**Subject: Docket Nos. 50-361 and 50-362  
Response to Request for Additional Information on the Response to  
NRC Generic Letter 2008-01  
San Onofre Nuclear Generating Station, Units 2 and 3**

**Response to Request for Additional Information on the Response to  
NRC Generic Letter 2008-01**

Figure 1; RWST Pump Inlet Screen, Elevation View

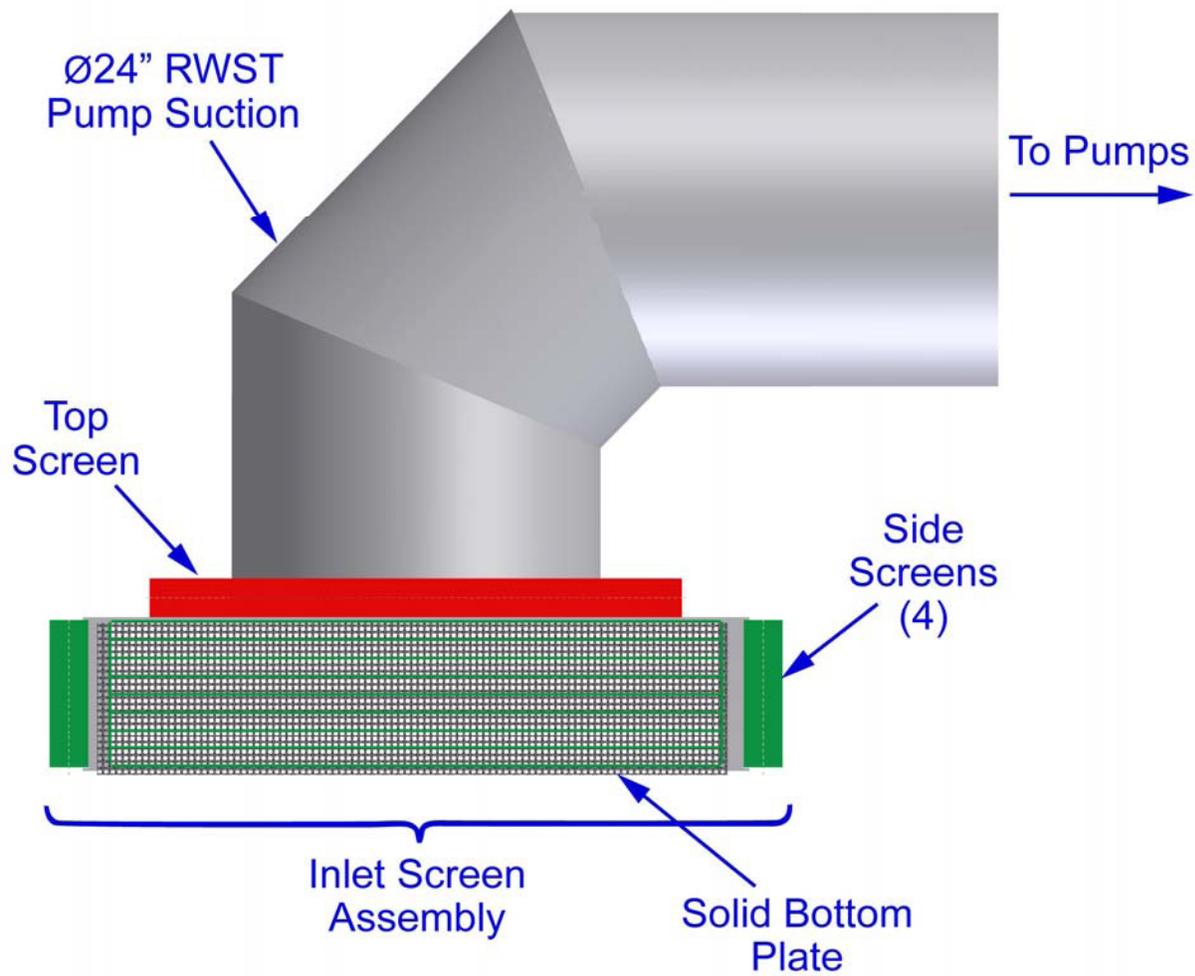
**Provide a justification that a water level of 3 inches above the bottom of the down-turned RWST suction elbow is enough to prevent gas ingestion due to vortexing during accident conditions. Since flow rates under realistic accident conditions (non-degraded pumps, two trains running) may significantly exceed the design basis accident flow rates, clarify whether the water level is applicable to actual expected accident conditions and for all modes of operation.**

To place the RWST air ingestion calculation (Reference 11) in context, an explanation of the RWST down-turned suction elbow configuration and piping configuration between the RWST and the Containment Emergency Sump (CES) tie-in to the Engineered Safety Features (ESF) pumps is needed. Figure 1 describes schematically the configuration of the RWST suction elbow and the screen box attached to it. The end of the RWST suction elbow pipe extends to the bottom of what is noted as the top screen. The top screen consists of a 10x10 screen mesh, sandwiched between pieces

of grating (Reference 12). The side screens consist of 10x10 screen mesh supported by grating on one side of the screen. The bottom of the screen box is a solid plate. The piping configuration for the RWST piping and the CES suction piping originating at the 14'-6" EL is shown in Figure 2. The RWST and the CES piping connect at the (-)3'-6" EL and continue to the ESF pump suction. Check valves are located in both the RWST and CES lines, denoted as S3-1204-MU-004 and S3-1204-MU-002. (Unit 3 Train B is the bounding piping configuration and is used in the evaluation.)

As noted in the Nine-Month GL Response (Reference 5), the 3-inch submergence for air ingestion into the RWST suction elbow is determined from a Create Inc. calculation (Reference 11). The 3-inch submergence is based on the depression of the fluid surface that would occur due to conversion of the static pressure at the fluid surface to velocity head at the RWST suction elbow entrance. The total flow through the pipe is 3500 gpm, as noted above. The RWST suction elbow is a 24-inch pipe with an inner diameter of 23.5 inches, leading to a flow velocity of 2.6 feet per second. Converting the velocity to a velocity head ( $v^2/2g_c$ ), a value of 1.3 inches water column (wc) is obtained. Including the pipe entrance loss coefficient of 0.8, the head loss increases to 2.3 inches wc ( $(1.3'' \text{ wc}) \times (1.0 + 0.8)$ ). The 10x10 screen mesh surrounding the pipe entrance corresponds to an area of approximately 9.6 square feet. The 10x10 mesh is constructed of 0.025 inch wire, which yields a 50% clear area. As such, the flow velocity through the mesh for a 3600 gpm flow through a 4.8 square foot clear area is 1.6 feet per second, which results in a velocity head of 0.4 inches wc. This mesh head loss is added to the preceding head loss at the pipe entrance to obtain a total head loss of 2.7 inches wc. This value is then conservatively rounded up to 3 inches wc. Therefore, it is expected that the depression of the fluid adjacent the RWST suction elbow, as show in Figure 3, will reach the pipe entrance when the fluid level is 3 inches above the suction elbow pipe end. It should be noted that this evaluation conservatively does not consider the ability of the inverted pipe entrance of the RWST suction elbow, nor the mesh and grating that surrounds the RWST suction elbow, to suppress any swirling flow that could result in an air core vortex.
